APPENDIX E.13.1

Responses to Intervenor Comments on the 2024 QIA-NWB Annual Report for Operations

Mary River Project**Water Licence No. 2AM-MRY2540****Prepared by: Baffinland Iron Mines Corporation****Submitted to: Nunavut Water Board****Date: March 31, 2026**

Table A.1: Response to QIA Comments on Baffinland’s 2024 QIA-NWB Annual Report for Operations

WASTE ROCK FACILITY: THERMISTOR LOCATION MAP

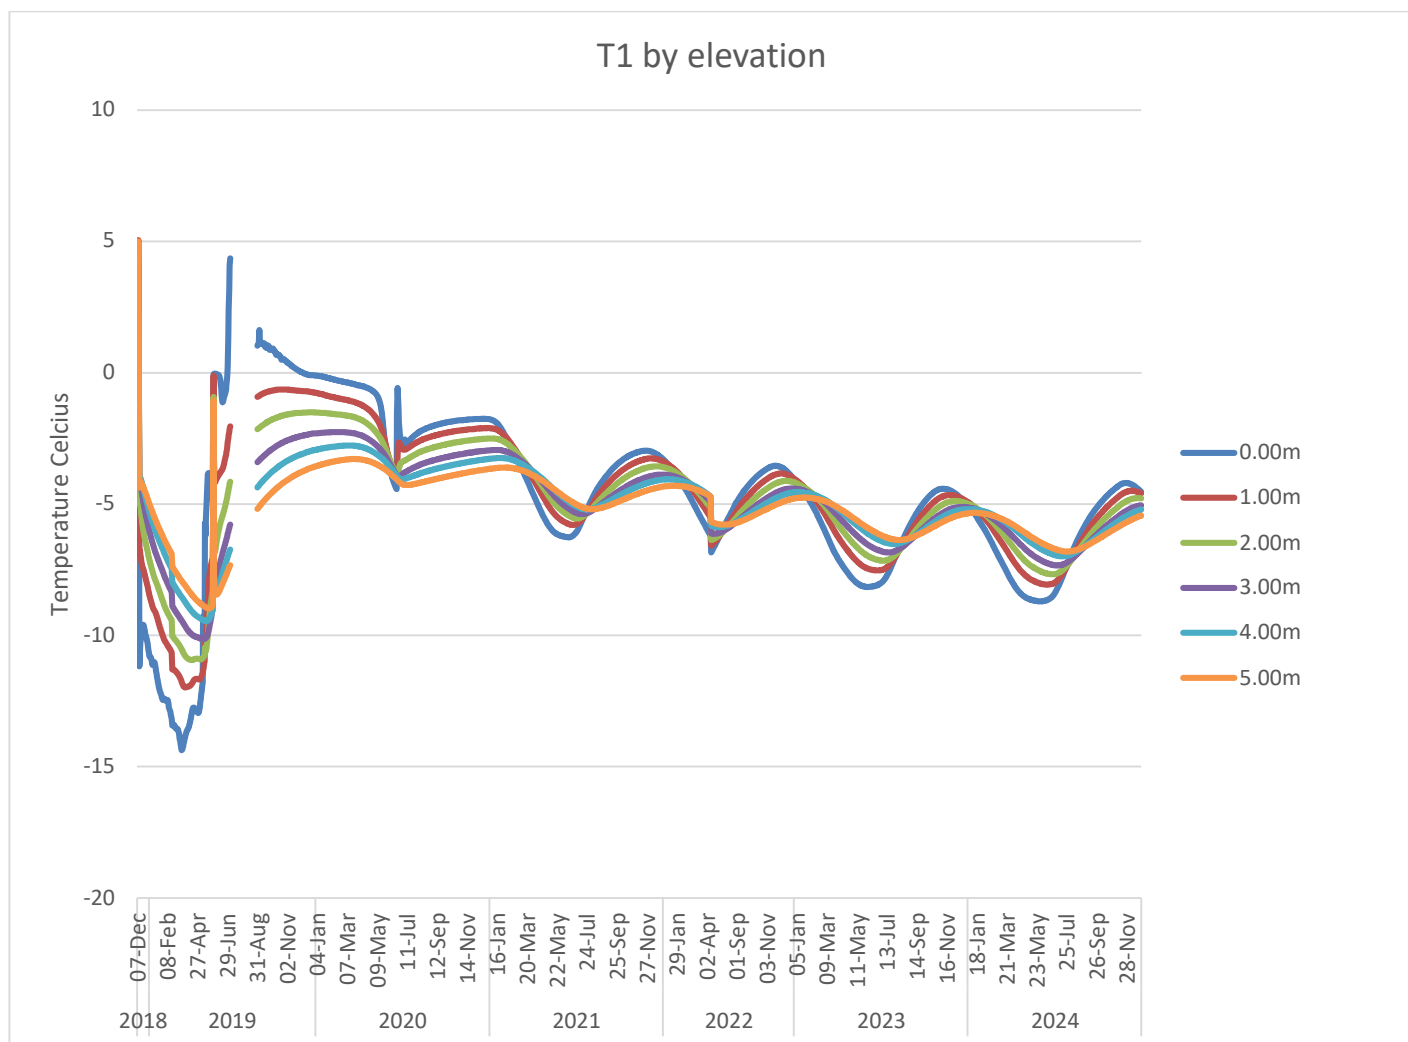
CIRNAC requested that Baffinland provide monitoring results for all instrumentation in operation at the WRF, in tables and graphs showing evolution over time and depth. Baffinland has responded by including Appendix E.13.1C, "July 2025 Waste Rock Facility Thermistor Monitoring," as well as annual WRF thermal monitoring data, tables, and graphs in Appendix E.15.1 of the 2025 Annual Report. Those materials present the thermal monitoring results in the format requested and provide the basis for review of temporal and depth-related trends. Baffinland therefore considers R-05 closed.

Figure D1: Location of Work Plan Item 2020-4

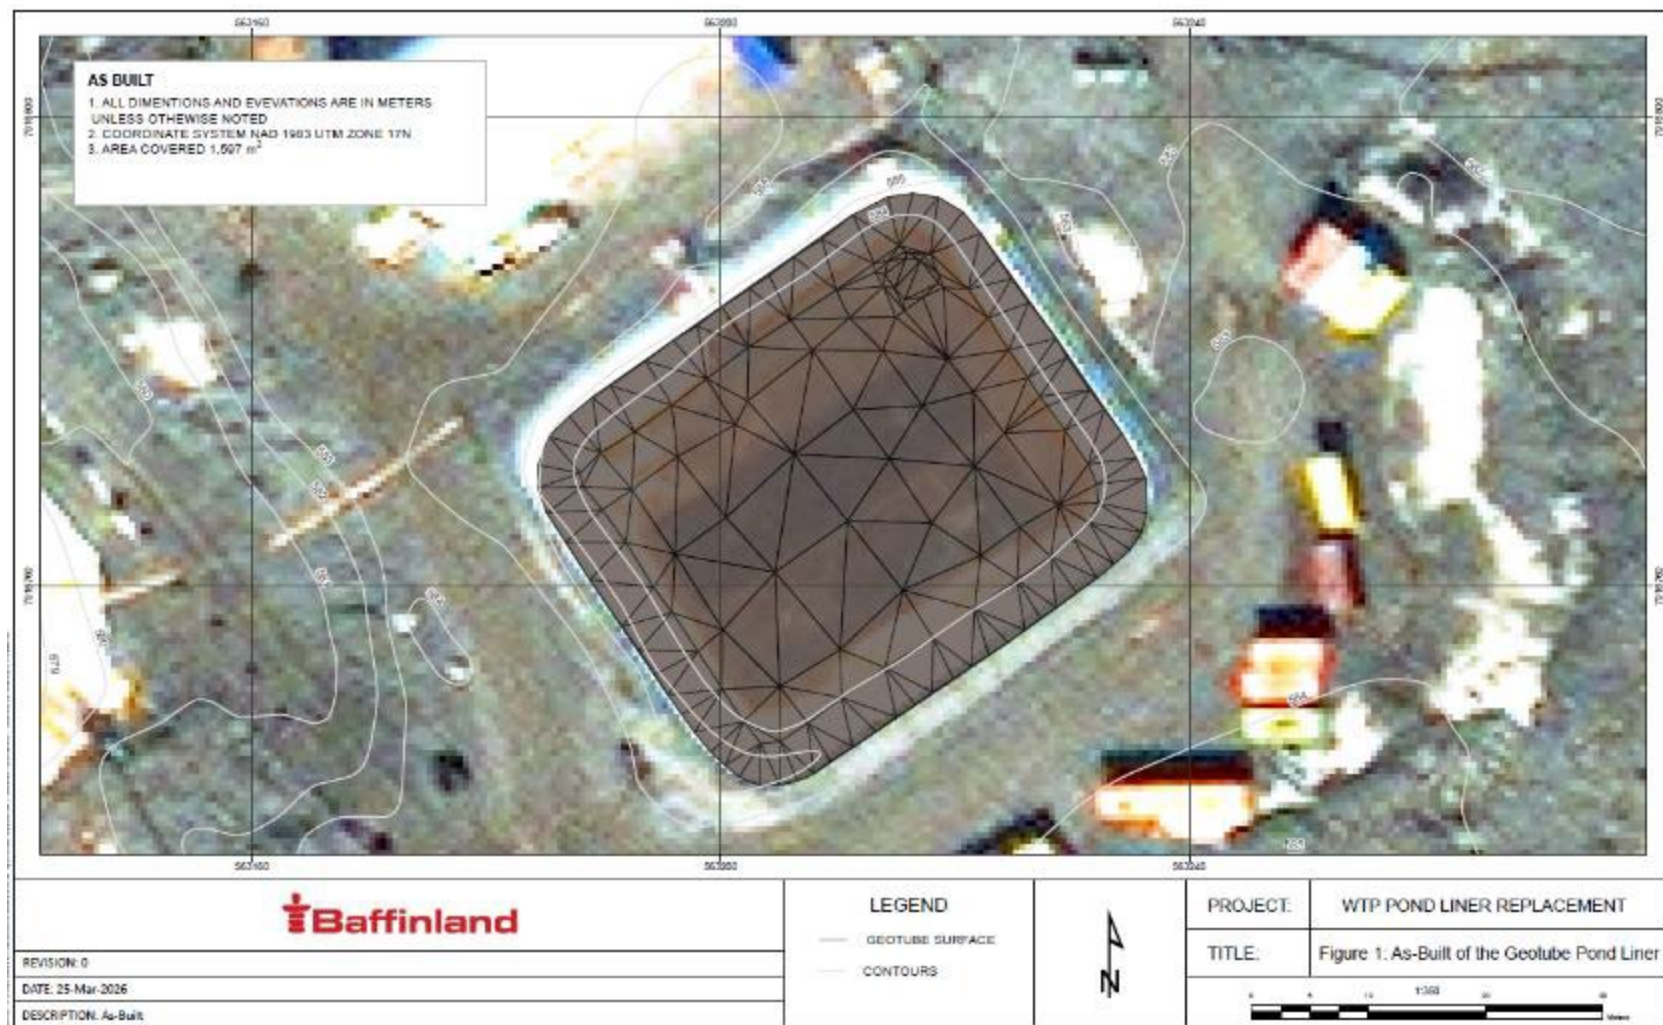
R-07	Construction Works at the WRF	Per Section G, Item 4, the Water Licence requires Baffinland to provide “A summary, including photographic records before, during and after construction activities, of any modifications and/or major maintenance work carried out on facilities and Infrastructure designed to contain, withhold, divert or retain Water or Wastes, and an outline of any work anticipated for the next year”. Section 2 of the 2024 Annual Report does not include a summary of the construction activities at the WRF. Appendix D.1 provides a picture of the WRF area with a caption mentioning the	(R-07) Provide a summary of the construction activities carried out at the WRF in 2024, including pictures that show the progression of the works. Additionally, include a list of the main construction activities planned for 2025 in this area.	Please see Appendix E.13.1D – As Built Report for the 2024 Geotube Pond Liner Replacement. Baffinland considers this item (R-07) closed.

CIRNAC requested a summary of construction activities carried out at the WRF in 2024, including photographs showing progression of the works, and a list of the main construction activities planned for 2025. Baffinland's response is that the relevant supporting documentation has been provided through Appendix E.13.1D, the As-Built Report for the 2024 Geotube Pond Liner Replacement. That appendix documents the work completed and provides the requested supporting record. Baffinland therefore considers R-07 closed.

Construction began on June 20, with the removal of the full Geotube from within the pond. From June 21-30, work was completed to replace the pond liner (damaged during Geotube removal). Construction was completed on June 30 with the new Geotube professionally installed within the newly replaced liner in the pond, complete with QA/QC. Construction took place within the existing disturbance footprint and not at the location identified below as Work Plan item **2020-4** (Figure D1).
